AGENDA
PLANNING BOARD
MEETING TIME 6:30 PM - MAIN MEETING ROOM
JANUARY 7, 2026

DATE: December 26, 2025
BOARD: Planning Board
APPLICATION: Christian Brothers Academy (#2025-206)
850 Newman Springs Road - Christian Brothers Academy
Block 1063, Lot 67.01
Minor Site Plan

**Re: Varsity Gymnasium Air Conditioning
Christian Brothers Academy
850 Newman Springs Road
Block 1063, Lot 67.01
Minor Site Plan
First Engineering Review**

DATE: December 19, 2025
BOARD: Planning Board
APPLICATION: Milano Builders
Walada Avenue & Arlington Avenue
Block 122, Lot 122; Block 158, Lot 1; Block 159, Lot 3
Preliminary & Final Major Subdivision with Variances

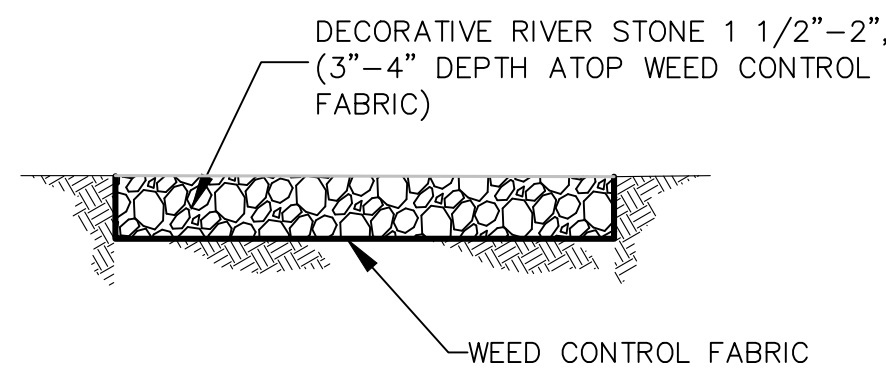
2. A construction detail shall be provided for the proposed fence.
3. We note that the existing sidewalk which is to be removed and relocated connects to the faculty parking lot to the east of the gymnasium. A note shall be added to the plans indicating that all improvements shall be in accordance with the current ADA regulations, where applicable.

EXTERIOR PAD / HVAC UNIT LOCATION PLAN

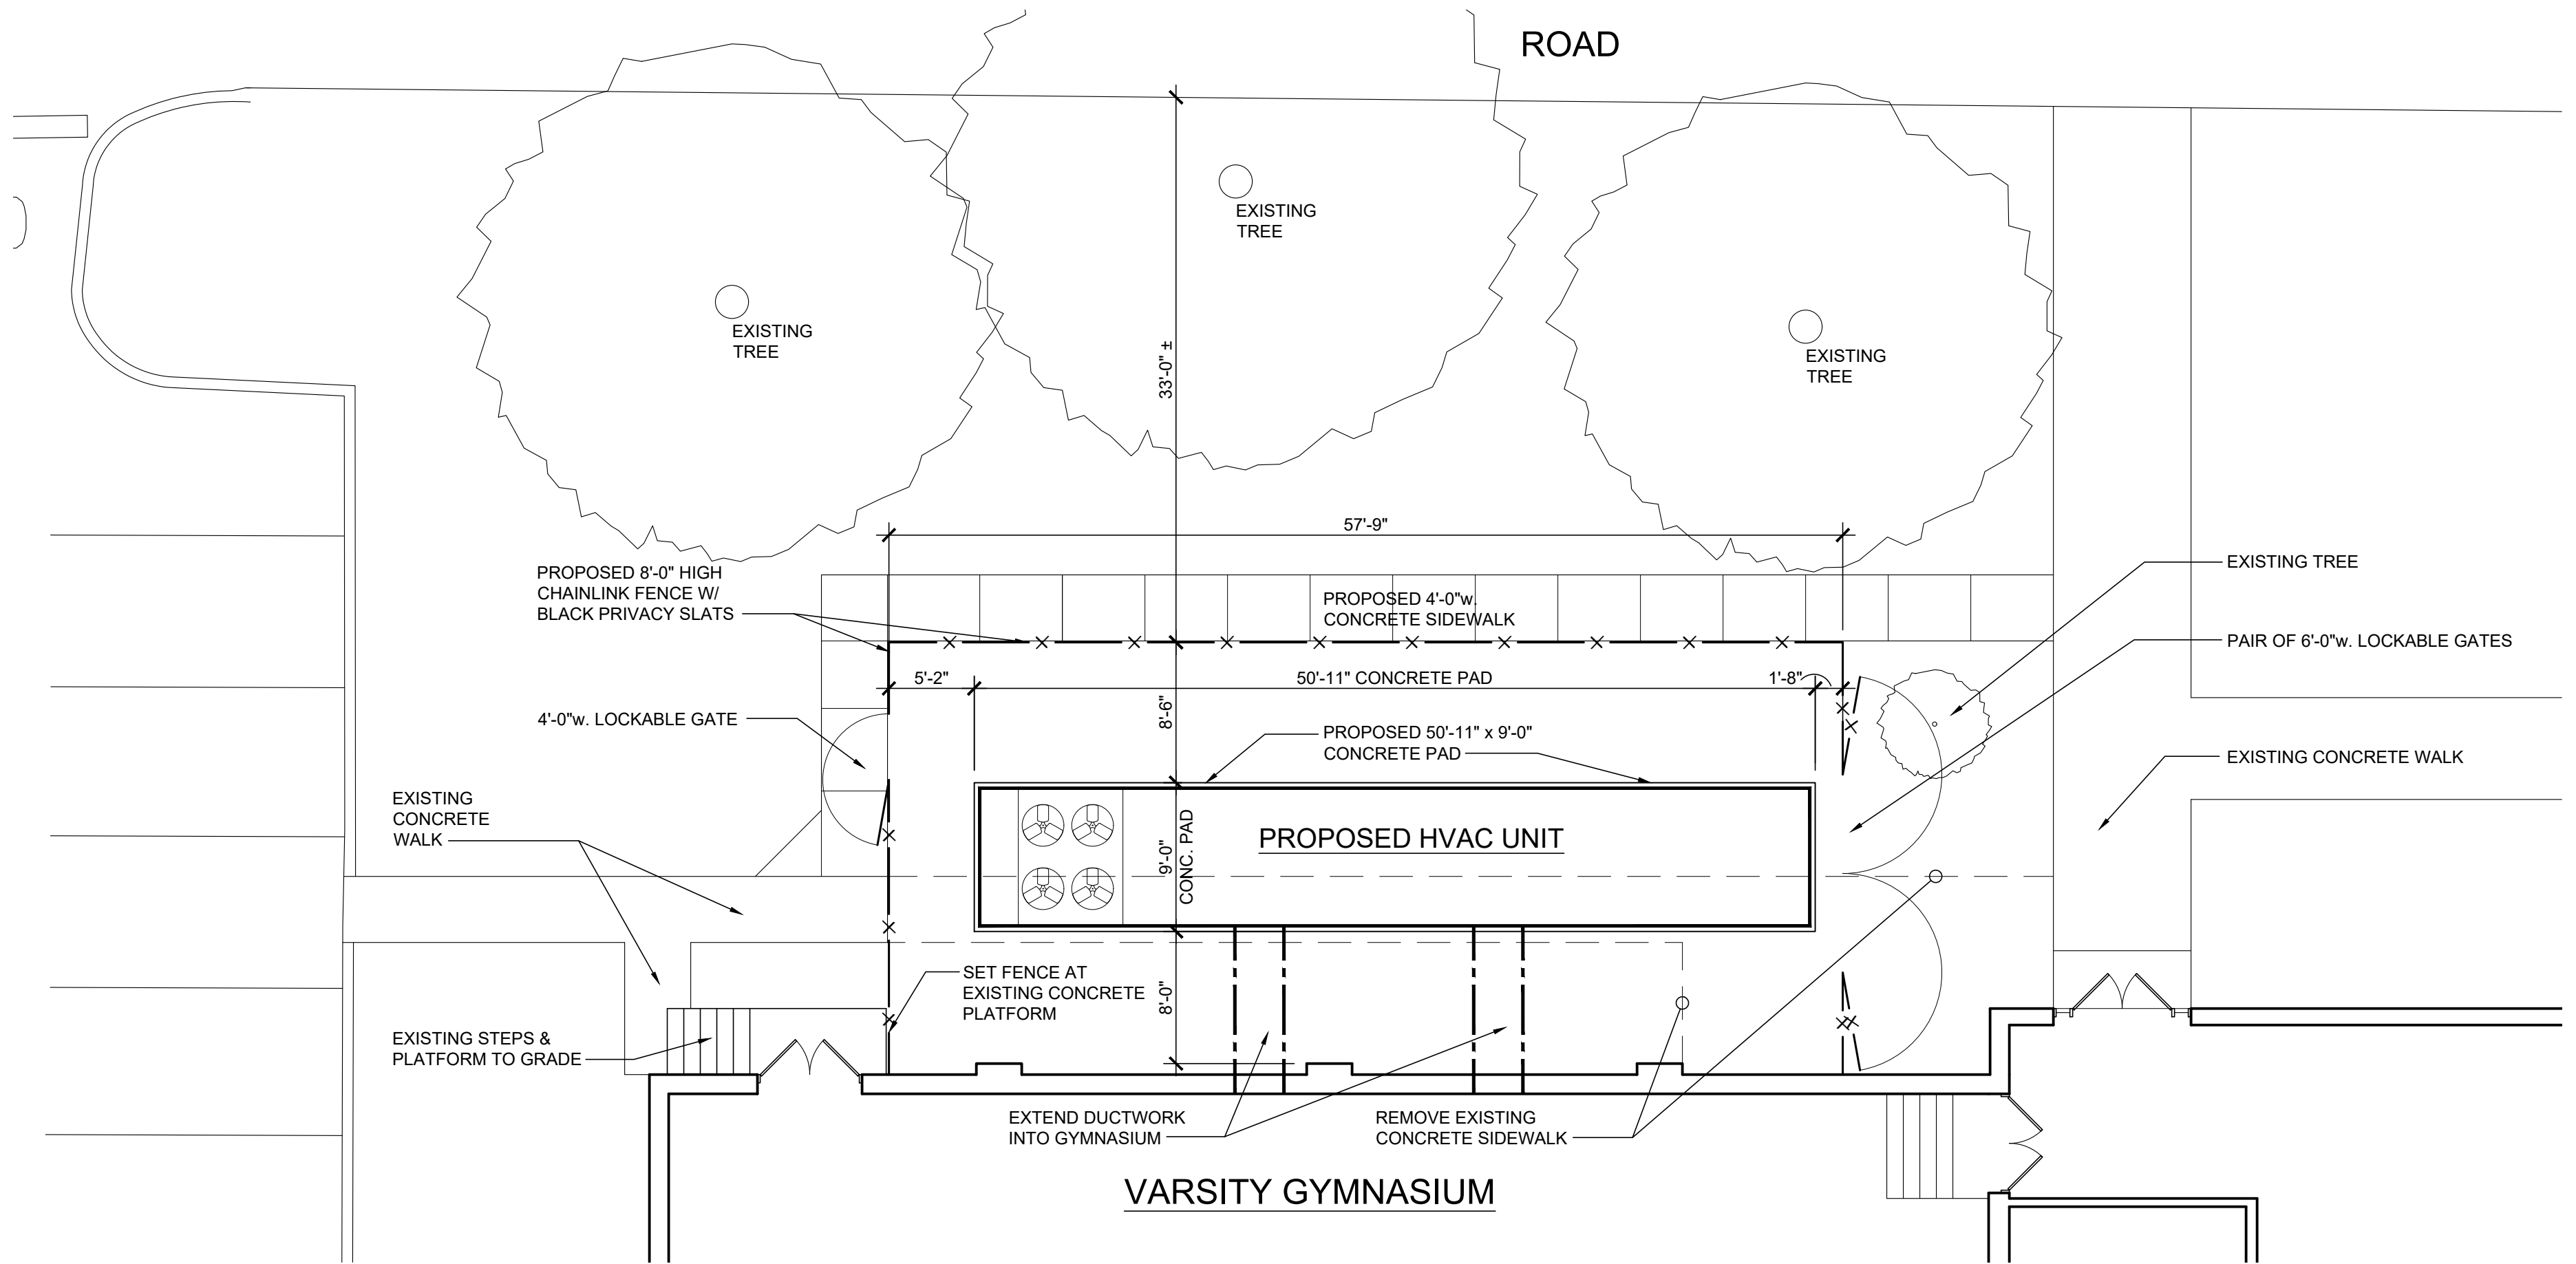
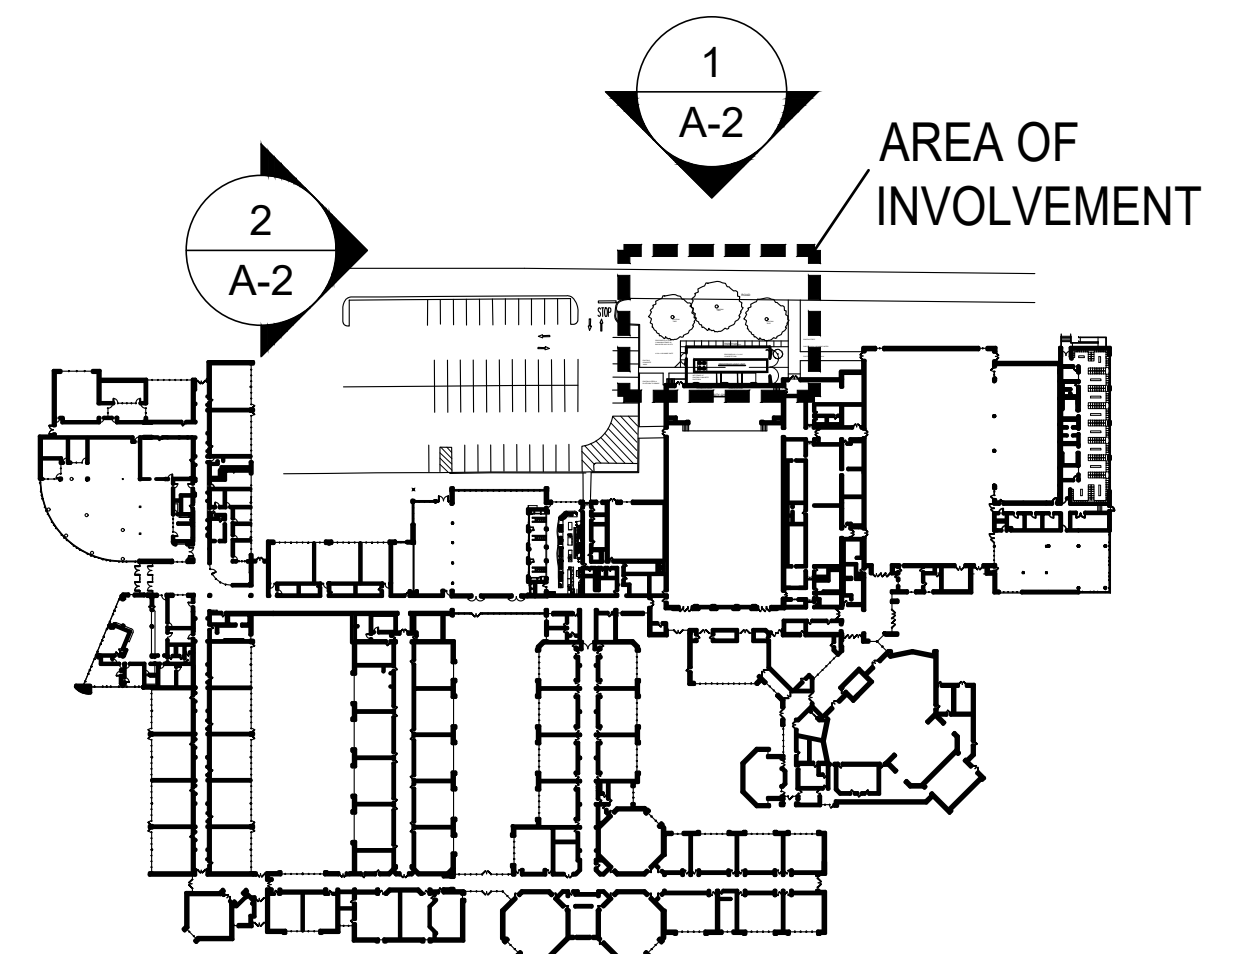
1. The applicant should clarify the height of the proposed HVAC unit. We note that as the unit is to be screened by an 8'-0" high chain link fence with privacy slats and the architectural elevation views indicate the unit will be slightly taller than the fence.
